State of New Mexico ENVIRONMENT DEPARTMENT Ground Water Protection and Remediation Bureau

May 10, 1996

RE: Source Area Investigation, Sparton Technology, Inc. (Sparton), Coors Road Facility, Albuquerque, NM

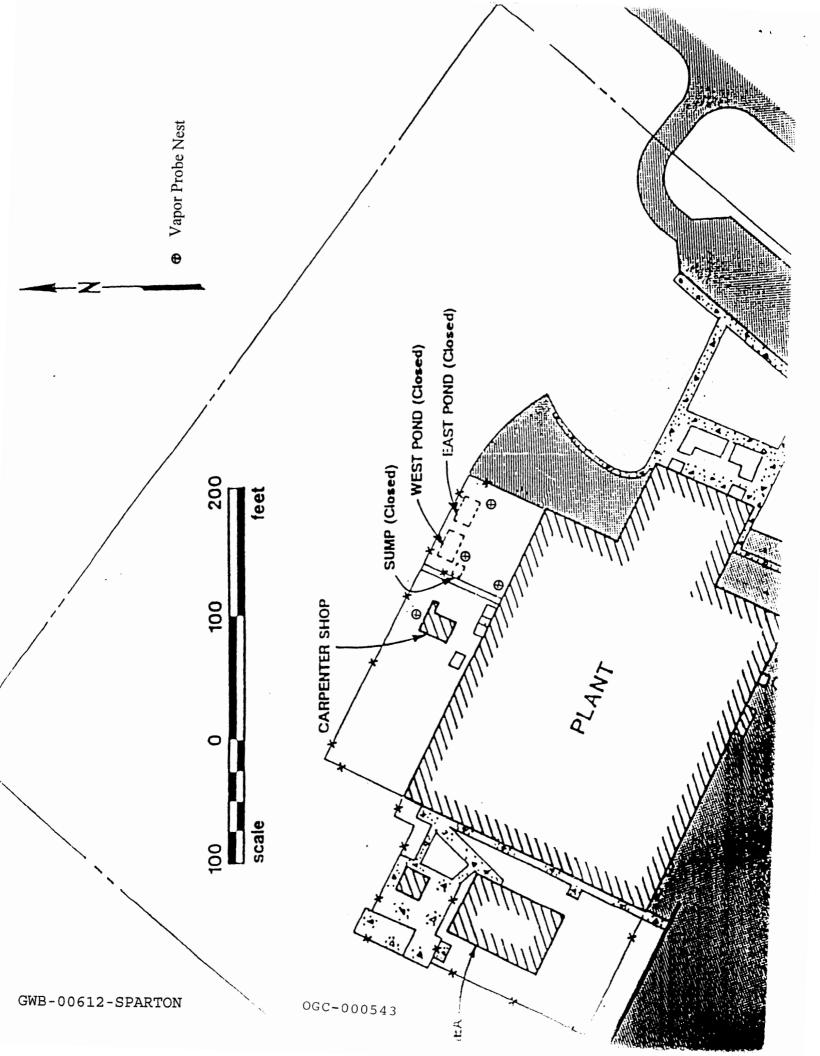
- 1) If Sparton decides to proceed with a phased voluntary approach to a comprehensive source investigation, a logical beginning would be the installation of a minimum of 4 nested vapor probes in and around the source area. A map showing these locations is attached. Drill cuttings and core samples should be collected during drilling to prepare a lithologic log of each boring. Core samples should be collected from each interval where a vapor screen will be installed and analyzed as solid-matrix samples in a laboratory.

VAPOR PROBE NEST

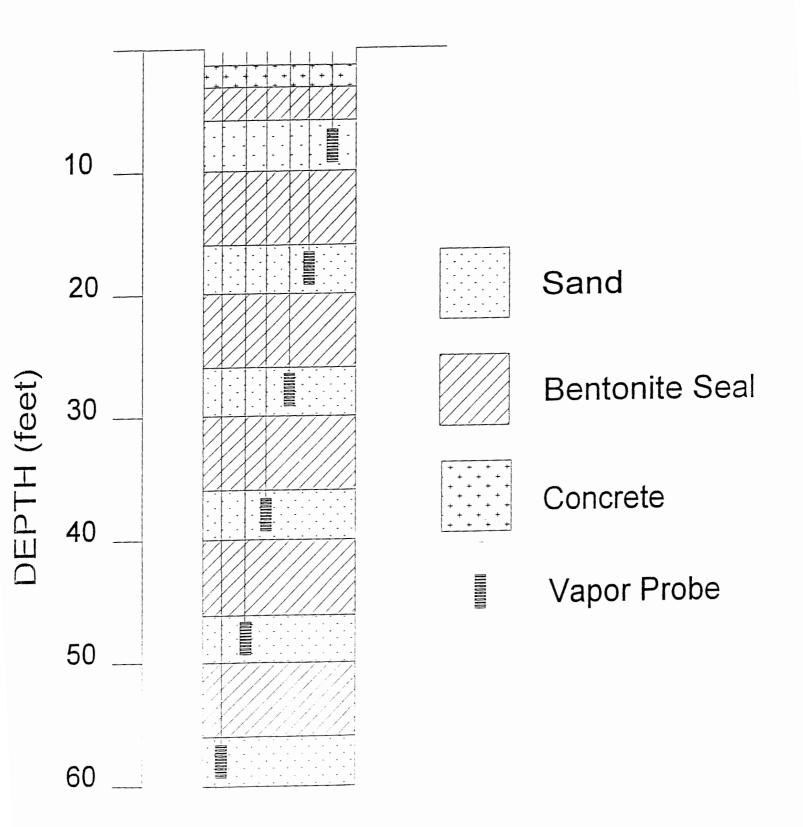
- 2) Specifications for vapor probe construction and sampling also are attached. In each nest, a probe should be installed approximately every 10 vertical feet. The exact depth of each vapor probe may be varied based on the lithology encountered in each hole. The probes should be installed in the coarsestgrained materials encountered in each 10 foot interval. Vapor samples should be analyzed for aromatic and halogenated volatile organic compounds (VOCs). Soil samples should be

- Screen: Constructed of a 12" to 18" length of 1/2" or 1" diameter 10-slot PVC screen. The screen should be capped on one end. On the other end should be a fitting which slips over the screen and has 3/4" internal threads on the other end. A brass fitting with 3/4" treads on one end and 1/4" compression union on the other end should be threaded into the fitting at the end of the screen. In no case should PVC cement be used.

- Riser Tube: 1/4" diameter copper tube that has been decontaminated (as is used for ice makers). The tubing is connected at one end to the compression union at the end of the screen. The screen is then lowered down into the hole as the tubing is uncoiled. The copper tubing should be marked with the depth and capped at the surface.

- Filter Pack: The volume surrounding the screen should be filled with a 12/20 silica sand. The sand should extend at least one foot above and below the screen.

- Seal: Between each screen/sand interval should be a low permeability seal. This seal should have a high bentonite content and a lower permeability than the surrounding formation. The material should be dry. If the interval of the seal is large, the middle portion can contain a higher permeability sand/bentonite mixture. However, each low permeability layer should be at least one foot thick.

- Sampling: A vacuum is applied to the end of each riser tube for a period long enough to remove a volume of air equal to at least three times the volume of the riser tube plus three times the volume of sand pack surrounding the vapor probe. A PID should be used to monitor the purged air. The PID values should be recorded. After purging is complete, an air sample should be collected in a Tedlar bag. Care should be taken to minimize any atmospheric air that may enter the Tedlar bag.
